# System Pillar / EULYNX Baseline Set 4 Release 2

Version: 2.4 Date: 30-06-2025

# **Error corrections**

# [EUP-516] Req. Spec. P: Incorrect IO Flow on SD 2.1.2.4.9 (Eu.P.5804) and 2.1.2.4.10 (Eu.P.5374) Created: 10.08.2023 Updated: 10.08.2023

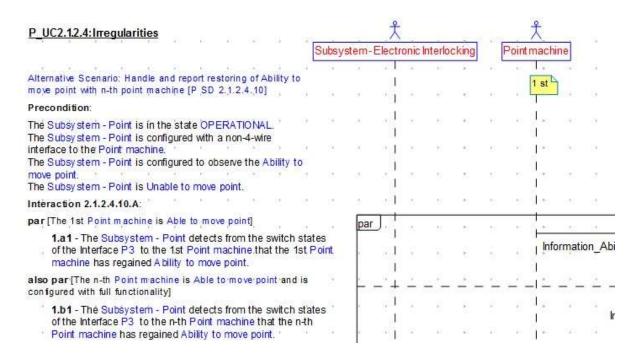
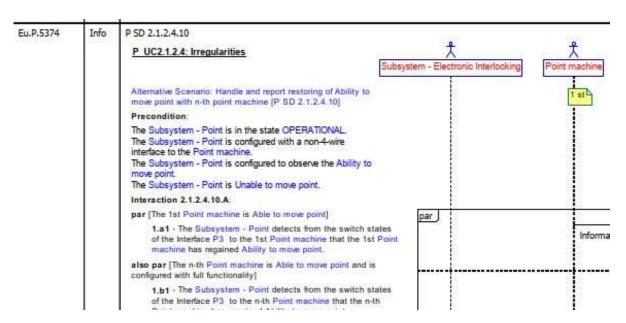
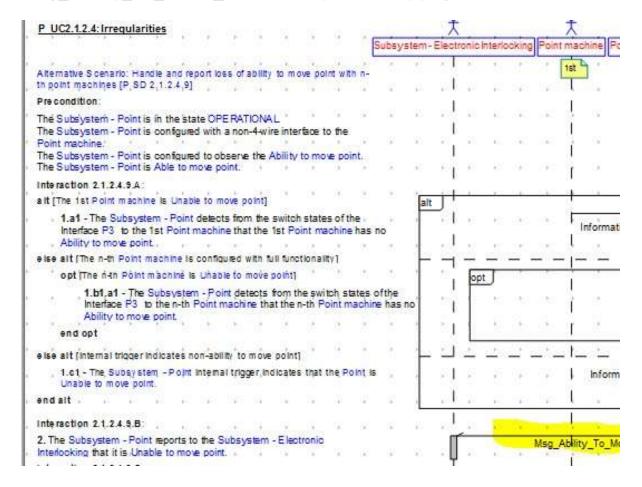
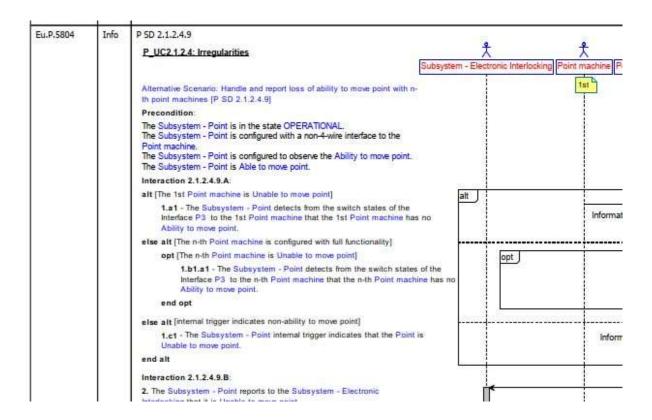
On SD 2.1.2.4.9 (Eu.P.5804) and 2.1.2.4.10 (Eu.P.5374) in on Step 2 a incorrect IO Flow is used (Msg\_Point\_Position).

Msg Ability To Move Point should be used.

### image-2023-08-15-13-44-53-576.png

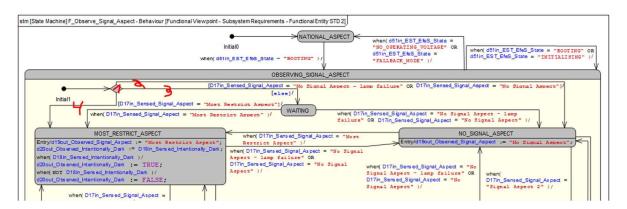
When the LS will be set from OPERATIONAL (while indicating "most restrict Aspect" back to BOOTING and then back to OPERATIONAL the controller is not able to report the newly set Aspect to the interlocking.

This is caused due to a deadlock in the observing block as it reacts just on the change trigger of D17 and can therefore not leave the state WAITING.

The STM for observe Signal Aspect shall be extended with transitions made of purely guard conditions (reacting on current state and not change trigger) as in attached pic shown. The four marked transitions/elements should be added to correct the described behaviour above.

Attachments:	20240710 Point STMs which were basis for BL4R2.pdf [EUP-	
	576] Correct STM diagram.png

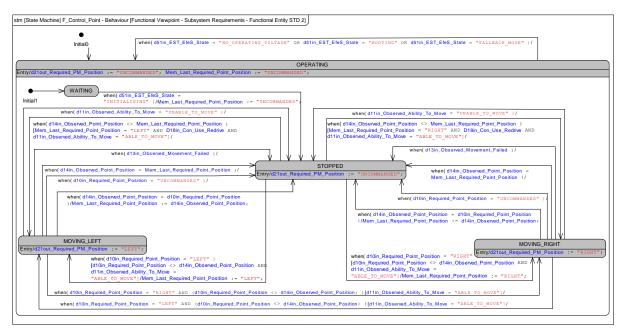
The correct transition must be d27in\_4W \_PM\_Position = "LEFT\_REACHED" / d27in\_4W \_PM\_Position = "RIGHT\_REACHED".

The correct transitions are shown in the attached figure.
